ALERT SERVICE BULLETIN

412-23-196

MODEL AFFECTED: 412EP

SUBJECT: MAIN INPUT QUILL ASSEMBLY 412-040-263-103
AND TAIL ROTOR DRIVE PINION QUILL
ASSEMBLY 212-040-365-133, REPLACEMENT OF.

Figure 1. Accessory and tail rotor drive and sump assembly.

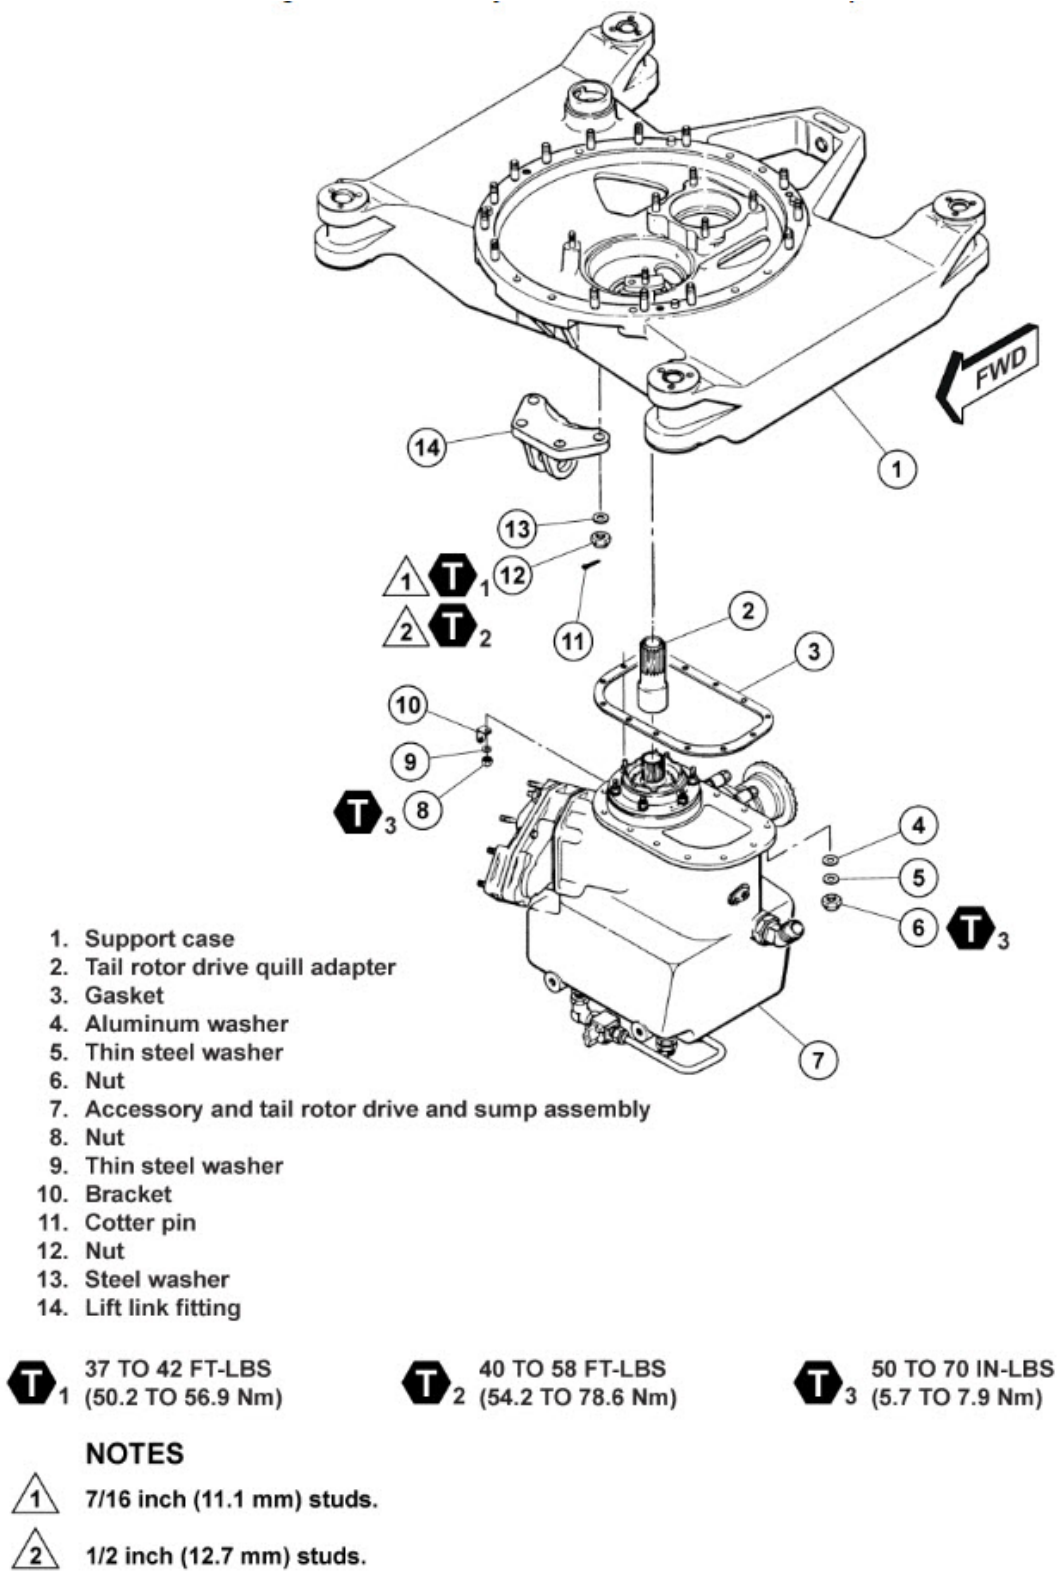
1. Prepare the helicopter for maintenance and remove transmission ([DMC-412-A-63-21-02-00A-520A-A](#)).
2. Remove the accessory and tail rotor drive and sump assembly (7, Figure 1) as follows:
 - a. Remove the nut (8), thin steel washer (9), and bracket (10).
 - b. Remove the twelve nuts (6) and the washers (4 and 5).
 - c. Remove the accessory and tail rotor drive and sump assembly (7) from the support case (1). Use a plastic or a rawhide mallet to tap the sump assembly and separate it from the support case.
 - d. Remove and discard the gasket (3).

6. Install the accessory and tail rotor drive and sump assembly (7, Figure 1) as follows:
 - a. If previously removed, put the tail rotor drive quill adapter (2) in the accessory drive quill in the support case (1).

- b. Put the new gasket (3) on the support case (1).
 - c. Put the accessory and tail rotor drive and sump assembly (7) on the support case (1) with the tail rotor drive quill on the aft side of the case. Secure the sump with aluminum washers (4) next to the sump, thin steel washers (5), and nuts (6) on each of the 13 studs with one exception; omit the aluminum washer and install the bracket (10), thin steel washer (9), and nut (8), on the stud directly above the magnetic chip detector in the sump. Torque the nuts (6 and 8) 50 to 70 inch-pounds (5.65 to 7.91 Nm).

Figure 2. Accessory and Tail Rotor Drive and Sump Assembly. (Sheet 1)

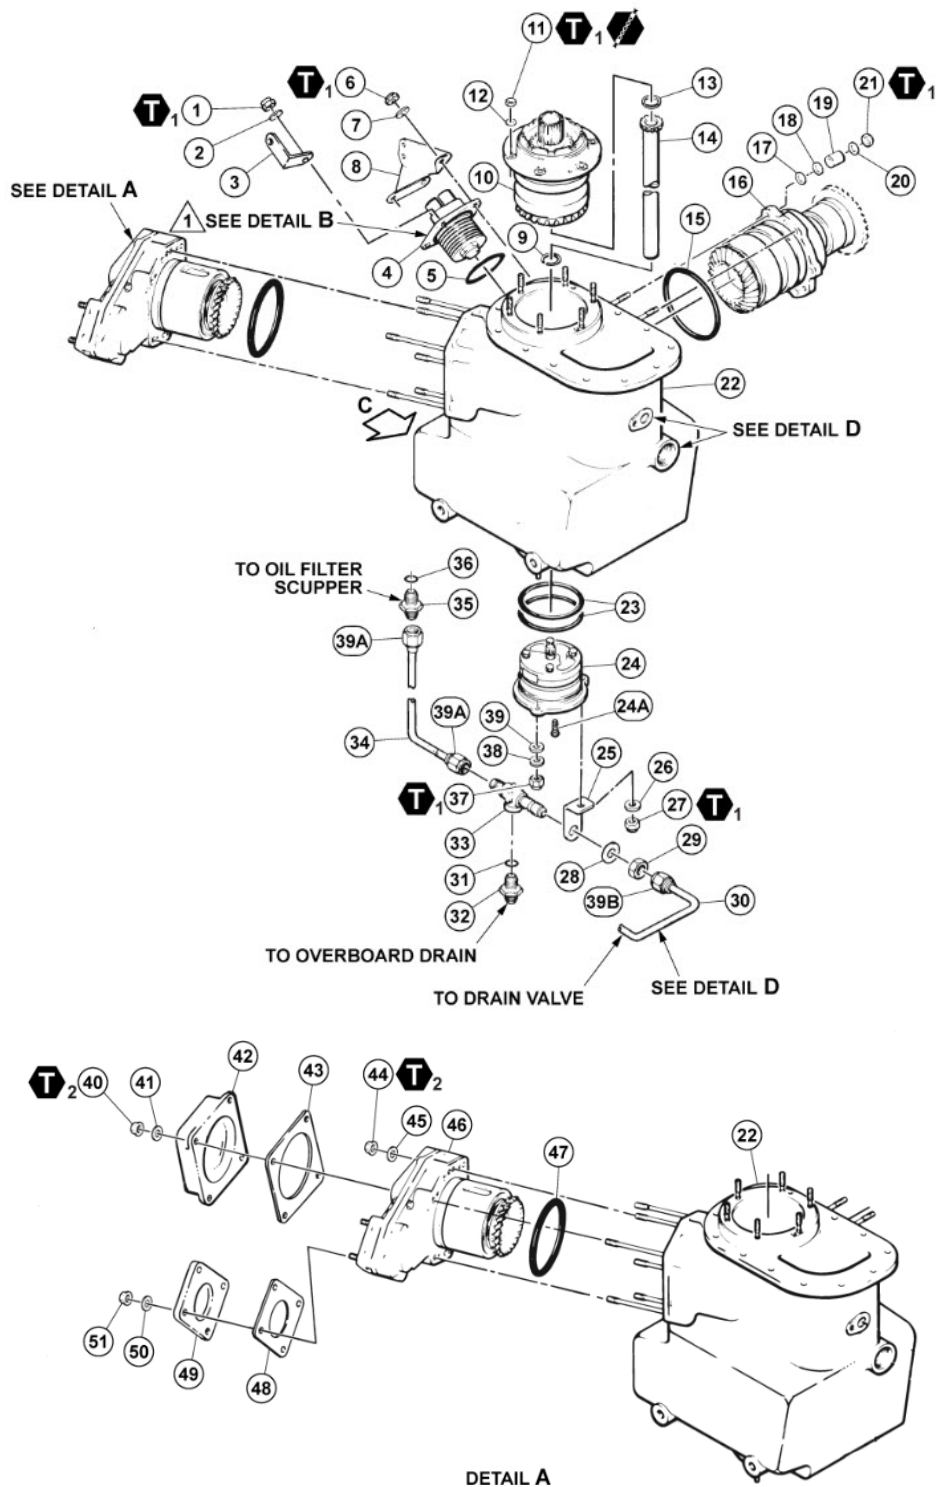
3. Remove the tail rotor drive pinion quill (10, Figure 2) as follows:
 - a. Cut and remove the lockwire.
 - b. Remove the six nuts (11) and steel washers (12).

- c. Install the Jackscrew Set (T101338) in the tail rotor drive pinion quill (10). Equally turn the jackscrews clockwise to pull the quill from accessory and tail rotor drive case (22).

- d. Remove the retaining ring (9).
 - e. Remove the oil pump shaft (14) and the retaining ring (13).
4. Install the new tail rotor drive pinion quill (10, Figure 2) as follows:

- a. Install the retaining ring (13) in the tail rotor drive pinion quill (10).
 - b. Put the oil pump shaft (14) in the quill and install the retaining ring (9).

- c. Heat the accessory and tail rotor drive case (22) at the port for the tail rotor drive pinion quill (10) with a heat lamp.
 - d. Coat the mating surfaces of the quill with the same oil used in the transmission. Put the quill in the case and install the six steel washers (12) and the nuts (11). Torque the nuts 50 to 70 inch-pounds (5.65 to 7.91 Nm). Secure the nuts in pairs with Lockwire (C-405).
